FOR
LANCASTER SEED SALES
2914 HOMESTEAD ROAD

SUBJECT: Lancaster Seed Sales
Preliminary/Final Land Development Plan Submission Modification Requests
DCG Project Number **5132-50**

Re: Lancaster Seed Sales
Preliminary/Final Land Development Plan
Township Permit No.25-07-FLDP
LCEC Project No: 25-190

We have received a preliminary/final land development plan submission from D.C. Gohn Associates, Inc. for the above-referenced project. The submission consisted of the following documents:

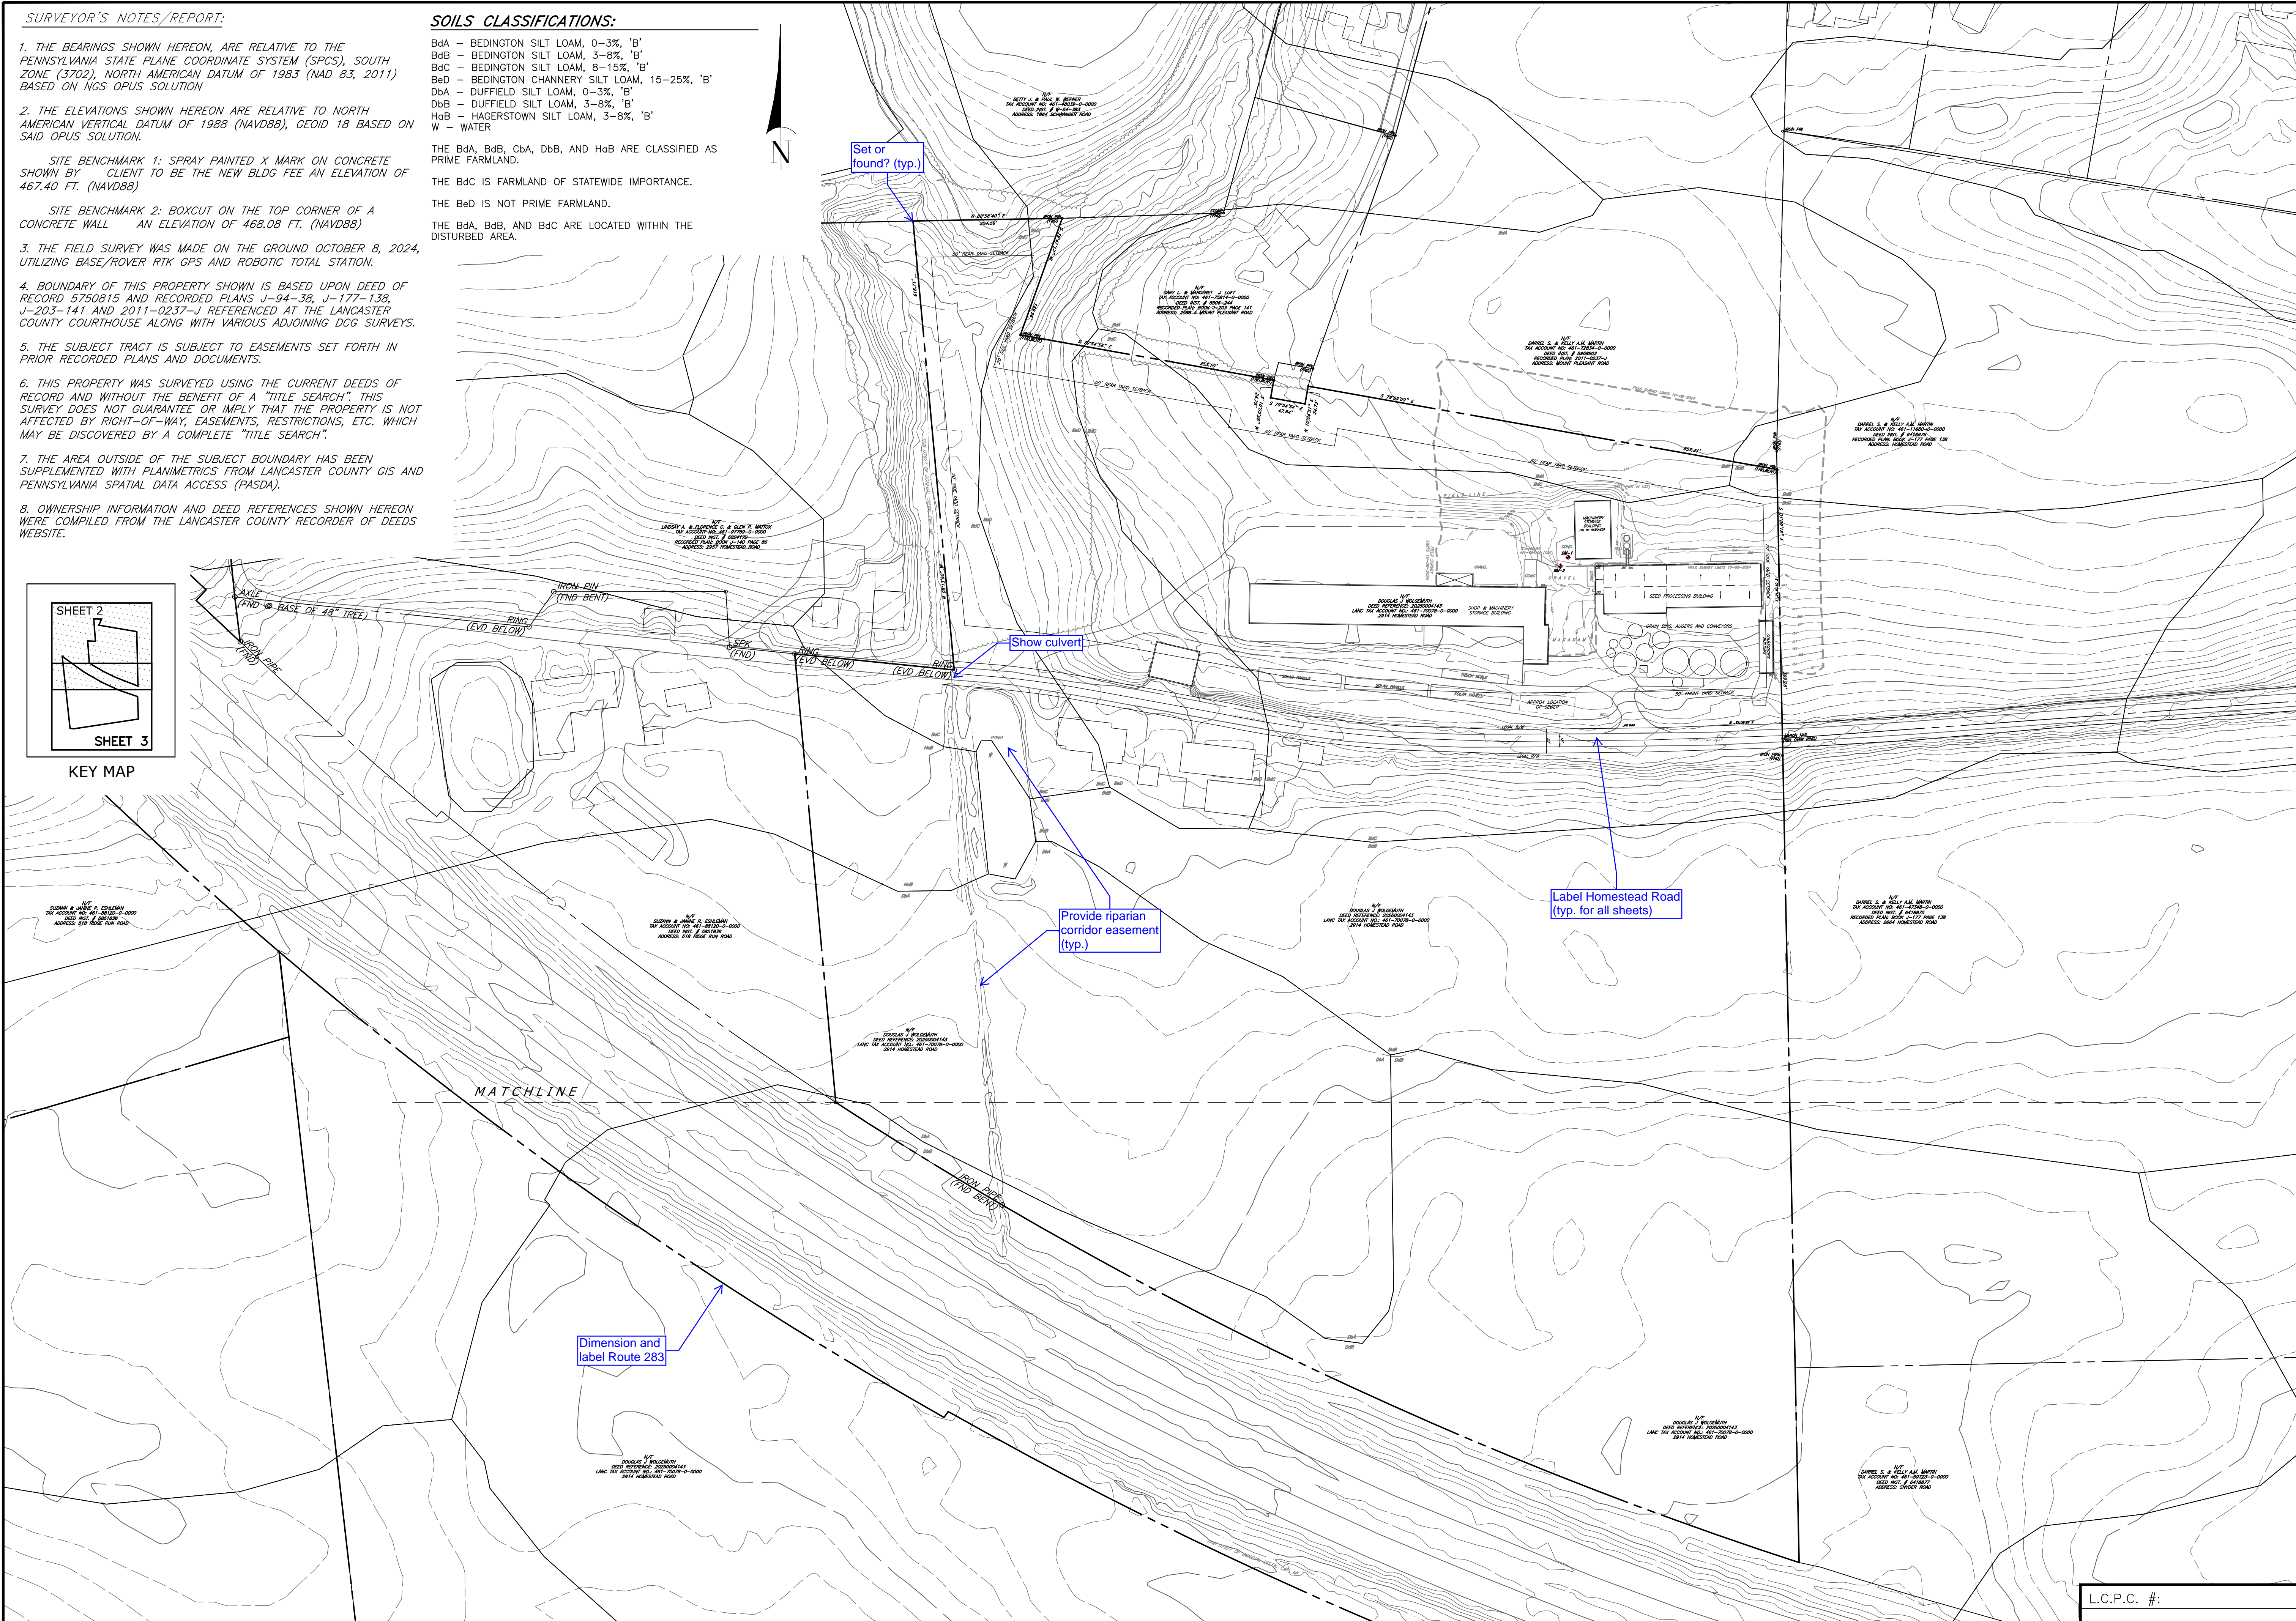
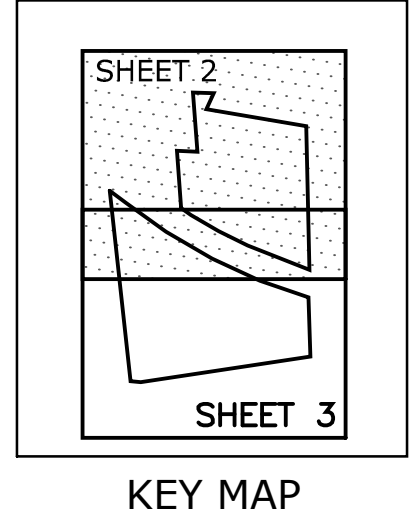
Site Note 3 of the Plan indicates that the Property is served by on-site sewer and water. Sheet 2 of the Plan shows an approximate location of an existing sewer system. There is no indication of a tested area for a replacement location. Will there be a replacement location determined?

LAYOUT AND EASEMENT PLAN	
PRELIMINARY/FINAL LAND DEVELOPMENT PLAN	
FOR	
LANCASTER SEED SALES	
2914 HOMESTEAD ROAD	
MOUNT JOY TOWNSHIP	
LANCASTER COUNTY, PENNSYLVANIA	
DRAWING #: CG-4053	
SHEET #: 5 OF 12

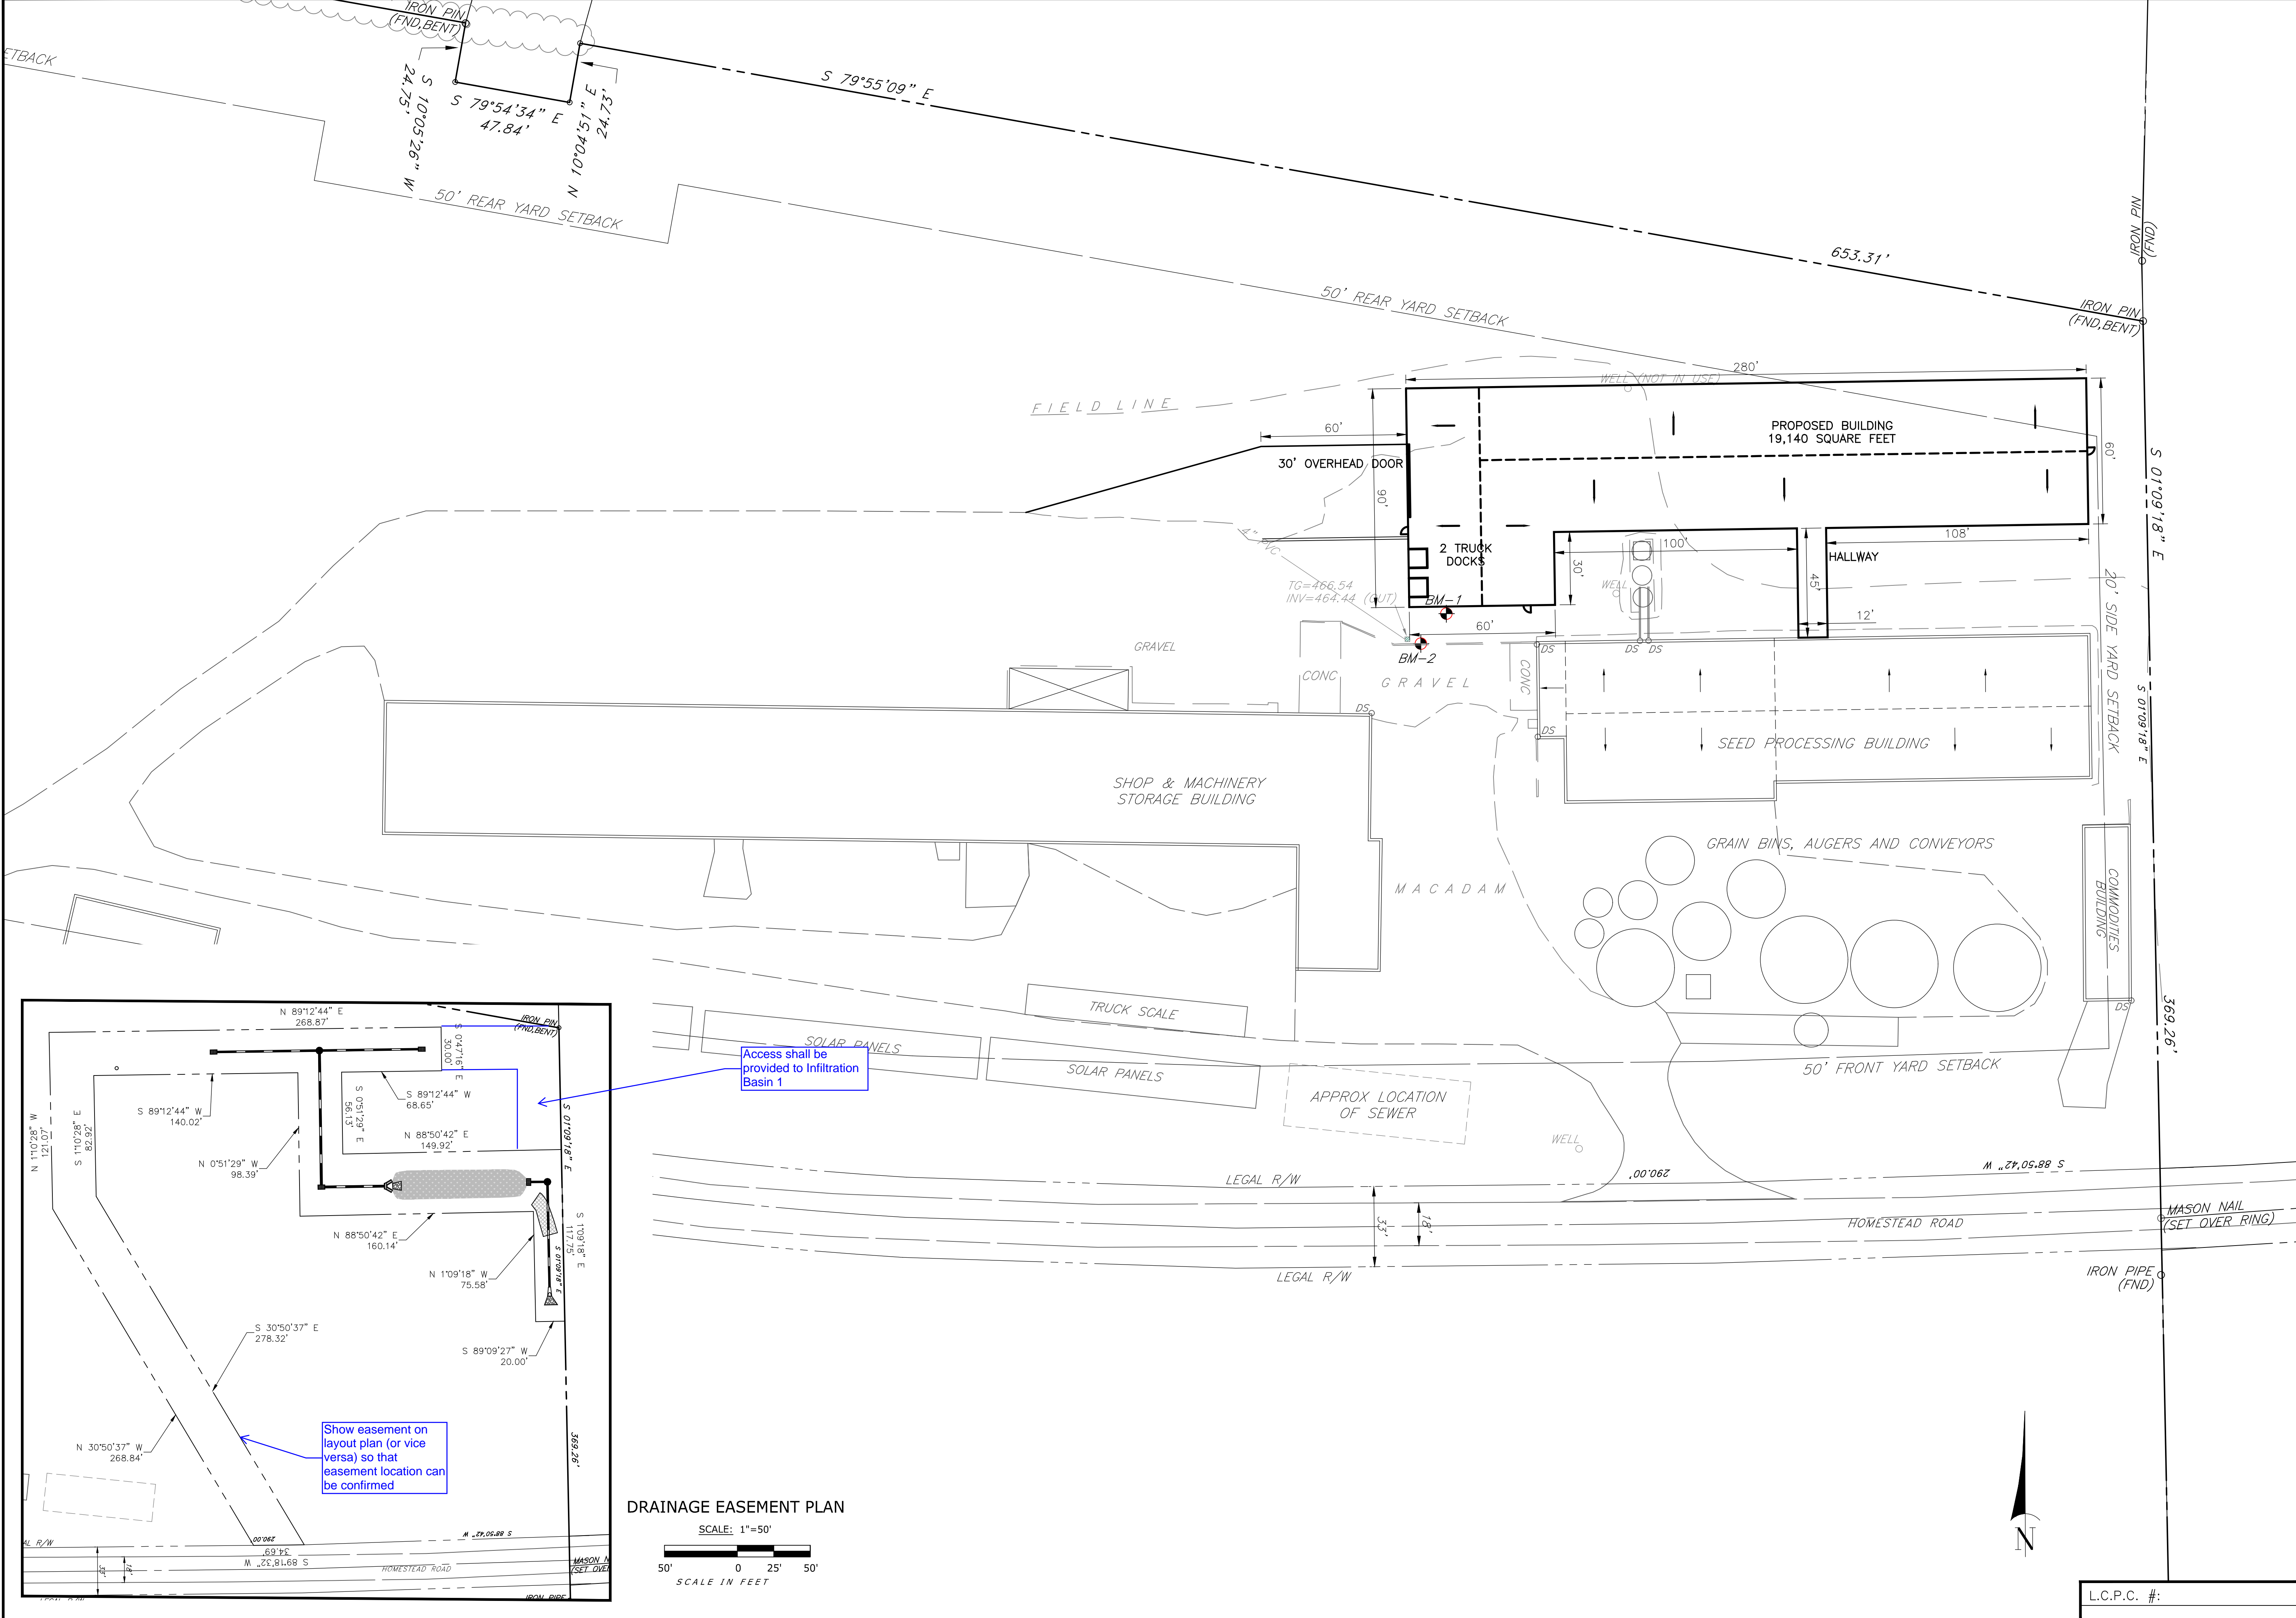
41. The proposed access and drainage easements shall be shown on the layout plan (or vice versa) to confirm the location of the easements. In addition, access to proposed Infiltration Basin 1 shall be provided (113-31.Q).
